# Product Change Notice (PCN)

PCN Number: **PCN-0454746R-01**

Product(s) Affected: SJ2-25102B-SMT-TR, SJ2-25103A-SMT-TR

PREVIOUS CUI DEVICES DETAIL / IMAGE	NEW CUI DEVICES DETAIL / IMAGE

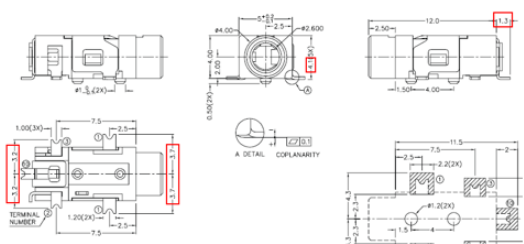
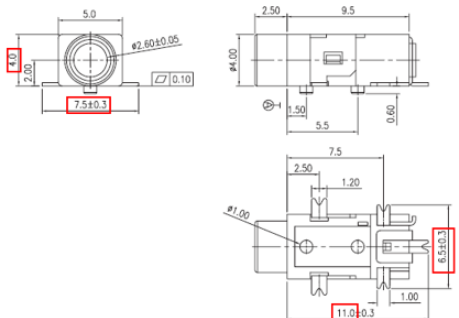
Description of Change: *Mechanical, material, soldering, and packaging changes as shown below:*

<p style="text-align: center;">Recommended PCB Layout Top View</p>	 <p style="text-align: center;">Recommended PCB Layout Top View</p>																																				
<table border="1"> <thead> <tr> <th></th> <th>MATERIAL</th> <th>PLATING</th> </tr> </thead> <tbody> <tr> <td>terminal 1</td> <td>copper alloy</td> <td>silver</td> </tr> <tr> <td>terminal 2</td> <td>copper alloy</td> <td>silver</td> </tr> <tr> <td>terminal 3</td> <td>copper alloy</td> <td>silver</td> </tr> <tr> <td>terminal 10</td> <td>copper alloy</td> <td>silver</td> </tr> <tr> <td>plastic</td> <td>PA10T</td> <td></td> </tr> </tbody> </table>		MATERIAL	PLATING	terminal 1	copper alloy	silver	terminal 2	copper alloy	silver	terminal 3	copper alloy	silver	terminal 10	copper alloy	silver	plastic	PA10T		<table border="1"> <thead> <tr> <th>DESCRIPTION</th> <th>MATERIAL</th> <th>PLATING/COLOR</th> </tr> </thead> <tbody> <tr> <td>terminal 1</td> <td>C5210 t=0.25</td> <td>gold flash over nickel</td> </tr> <tr> <td>terminal 2</td> <td>C5210 t=0.25</td> <td>gold flash over nickel</td> </tr> <tr> <td>terminal 3</td> <td>C5210 t=0.25</td> <td>gold flash over nickel</td> </tr> <tr> <td>terminal 10</td> <td>C2680 t=0.25</td> <td>gold flash over nickel</td> </tr> <tr> <td>housing</td> <td>PA10T (UL94V-0)</td> <td>black</td> </tr> </tbody> </table>	DESCRIPTION	MATERIAL	PLATING/COLOR	terminal 1	C5210 t=0.25	gold flash over nickel	terminal 2	C5210 t=0.25	gold flash over nickel	terminal 3	C5210 t=0.25	gold flash over nickel	terminal 10	C2680 t=0.25	gold flash over nickel	housing	PA10T (UL94V-0)	black

MATERIAL	PLATING																																			
terminal 1	copper alloy	silver																																			
terminal 2	copper alloy	silver																																			
terminal 3	copper alloy	silver																																			
terminal 10	copper alloy	silver																																			
plastic	PA10T																																				
DESCRIPTION	MATERIAL	PLATING/COLOR																																			
terminal 1	C5210 t=0.25	gold flash over nickel																																			
terminal 2	C5210 t=0.25	gold flash over nickel																																			
terminal 3	C5210 t=0.25	gold flash over nickel																																			
terminal 10	C2680 t=0.25	gold flash over nickel																																			
housing	PA10T (UL94V-0)	black
